# UNITED STATES PATENT AND TRADEMARK OFFICE

<b>Office Action Summary</b>	<b>Application No.</b> 09/582,817	<b>Applicant(s)</b> REMACLE, JOSE	
	<b>Examiner</b> Bradley L. Sisson	<b>Art Unit</b> 1634

## DETAILED ACTION

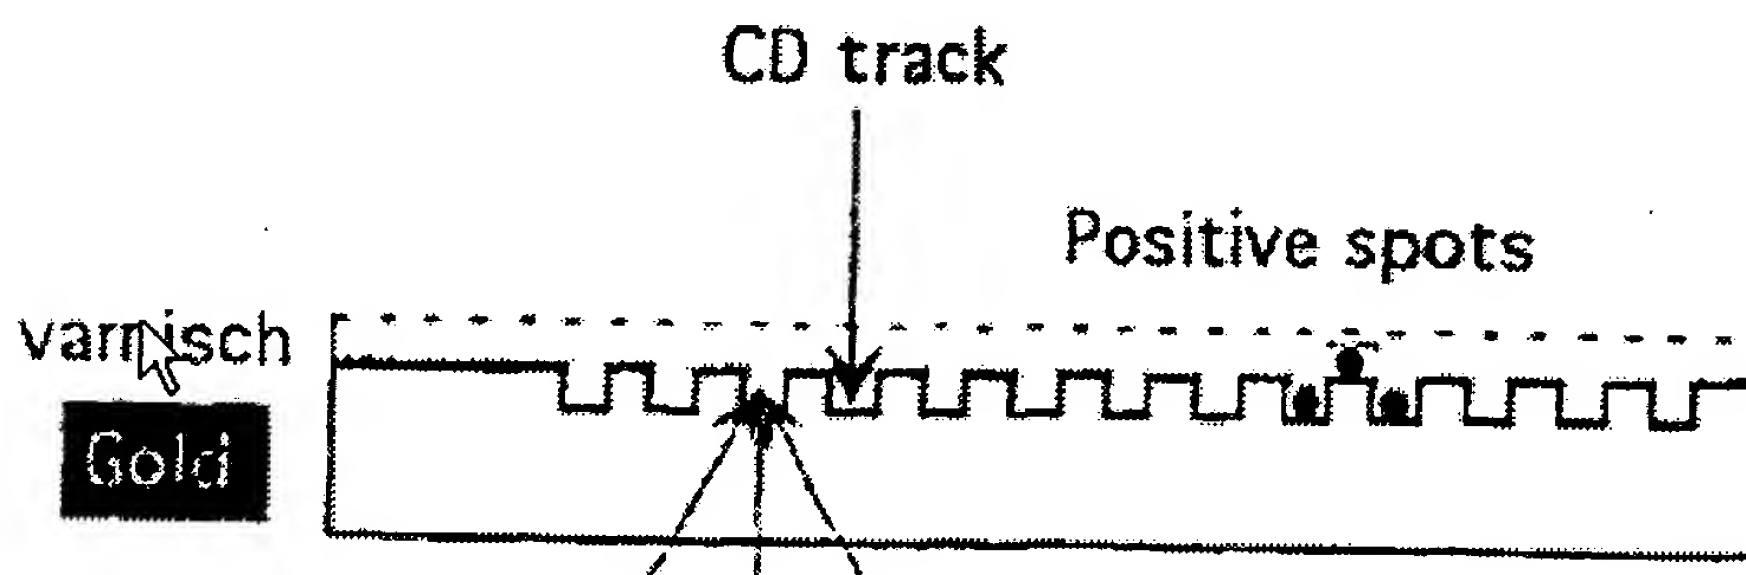
31. Claim 30 is confusing in that the solid surface is to be that of a compact disc (CD) or a digital video disc (DVD), which is recognized as having grooves on its surface. Said claim

requires the solid support (i.e., the CD or DVD) to not comprise “microchannels.” Fig. 3, *infra*, depicts the tracks, which appear to be microchannels.

It is unclear how a CD or DVD, which is recognized as having radial tracks that in essence form microchannels, yet said CD/DVD cannot have any microchannels. (Page 13, third paragraph, of the specification teaches that a CD may up to 20000 different radial tracks.) Claims 31, 34, 40-41, 44-45, 47, and 64, which depend from said claim 30, fail to overcome this issue and are similarly rejected.
